May 26, 2017

TO : All Bidders
FROM : George M. Wiens
PROJECT : CTE Classroom Addition
1615400.41
SUBJECT : Addendum 1
DSA : 04-115755 / 33-H18

DRAWING NUMBER: **E2.1**

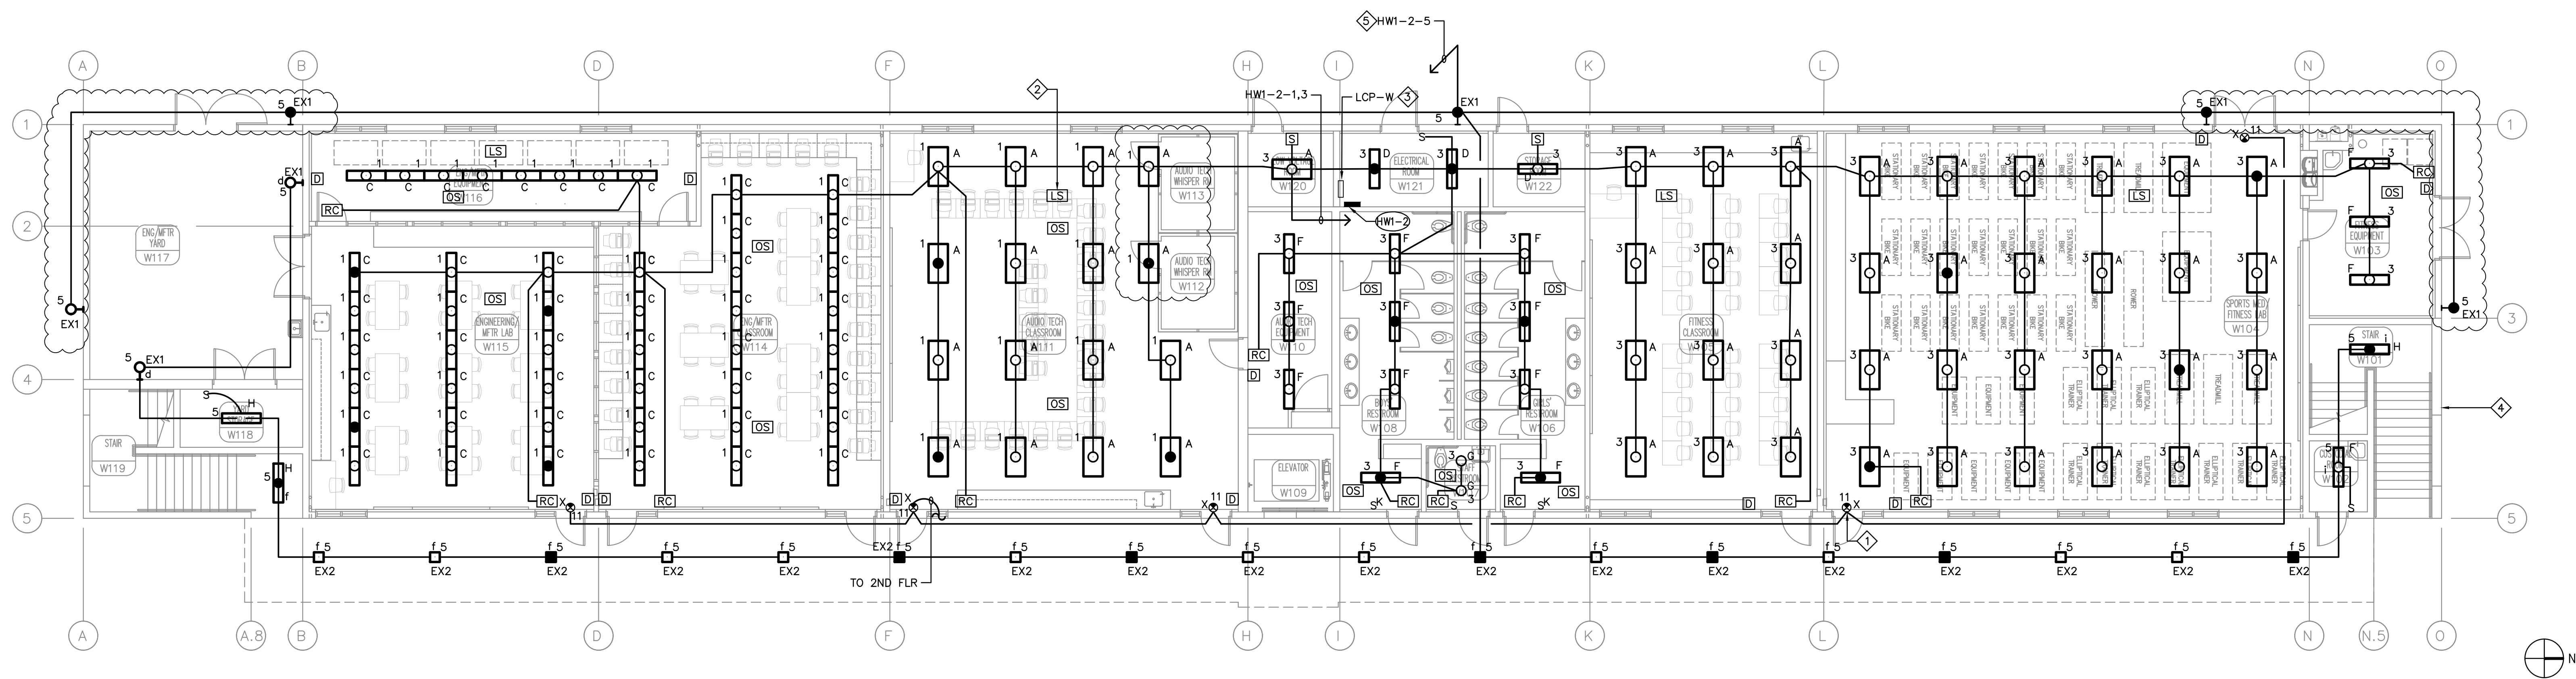
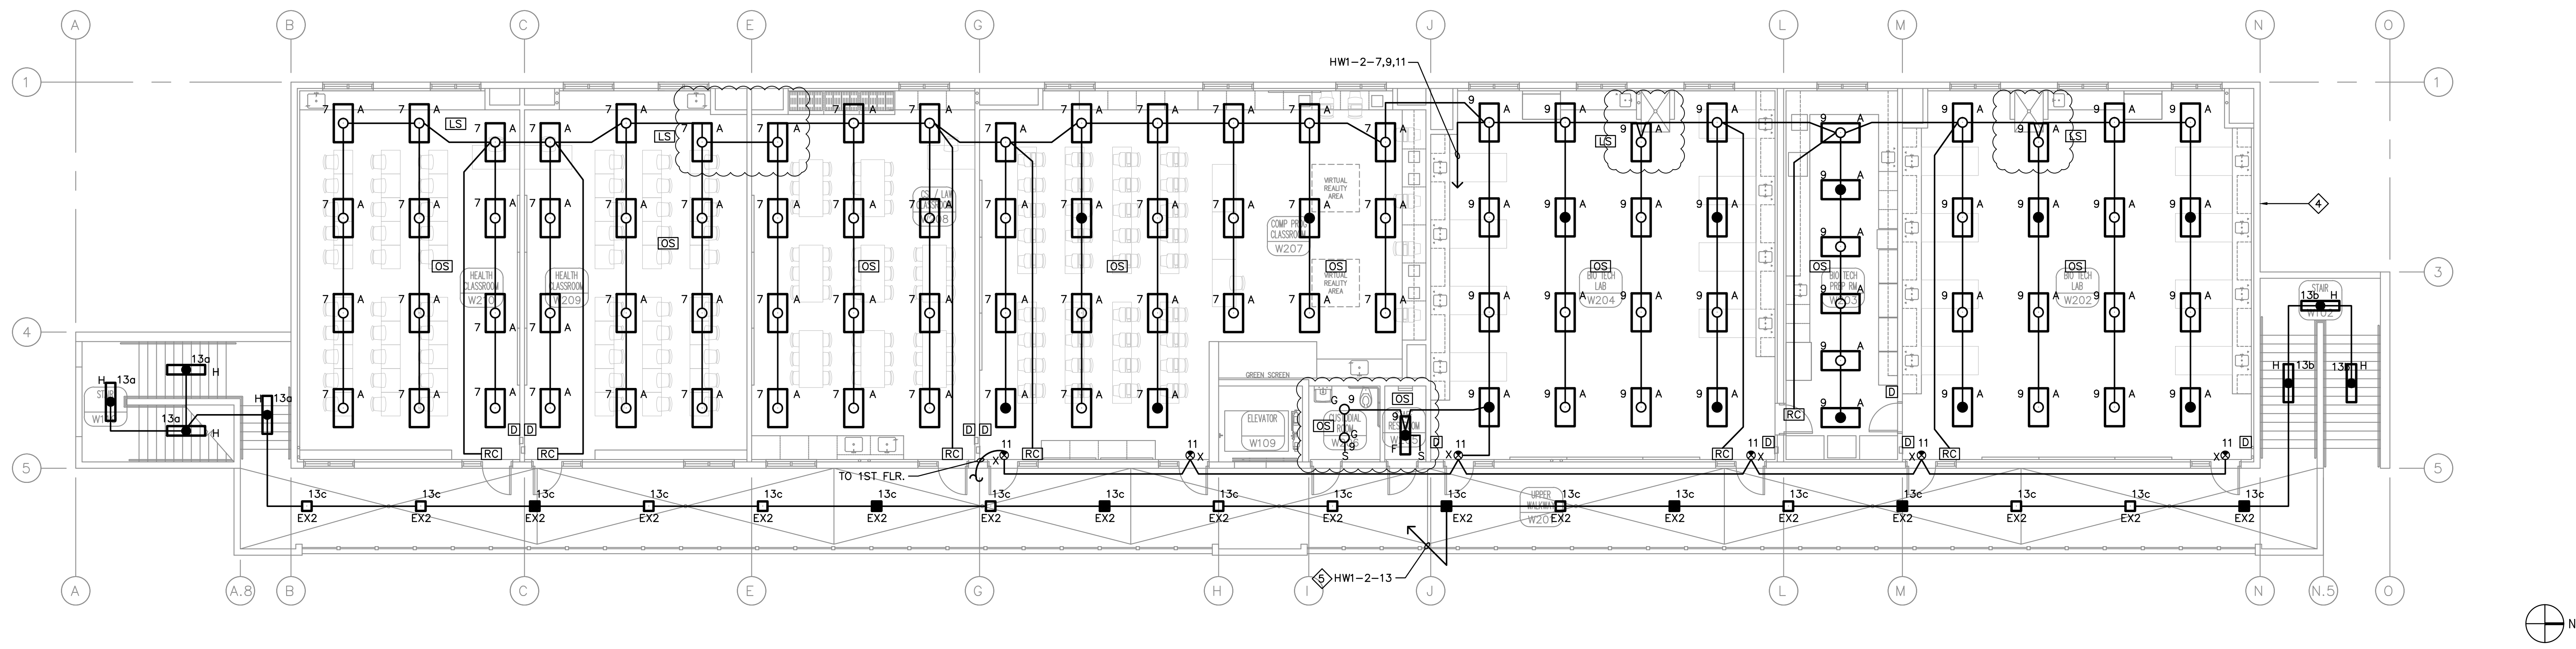
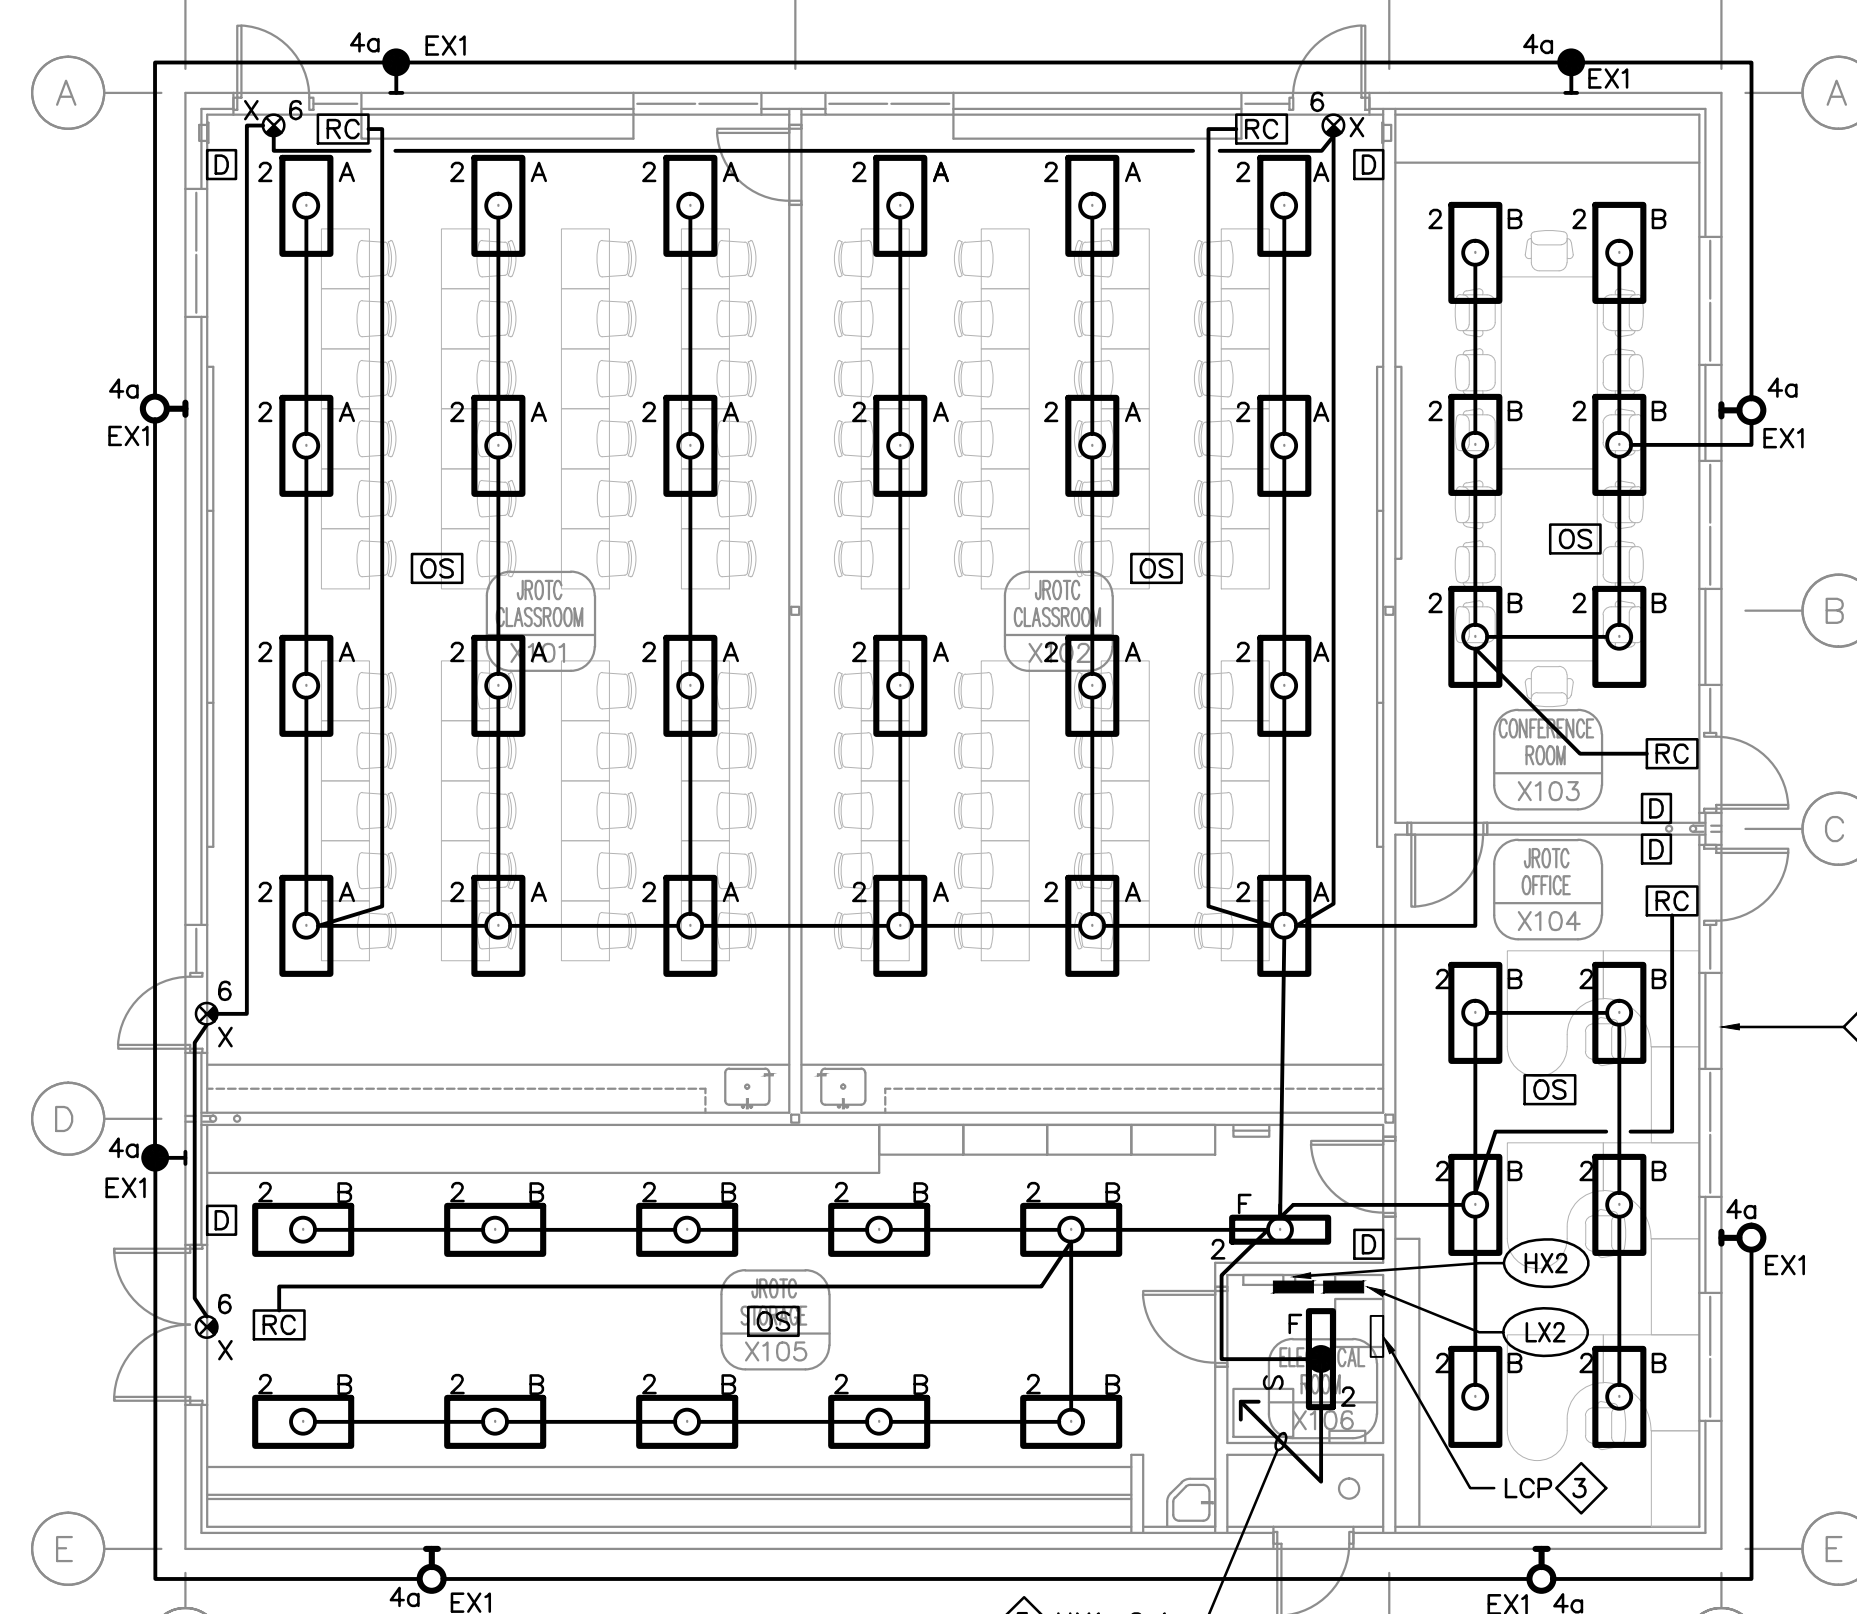
A. Revise as indicated in the clouded area labeled Delta 1 on the attached E2.1.
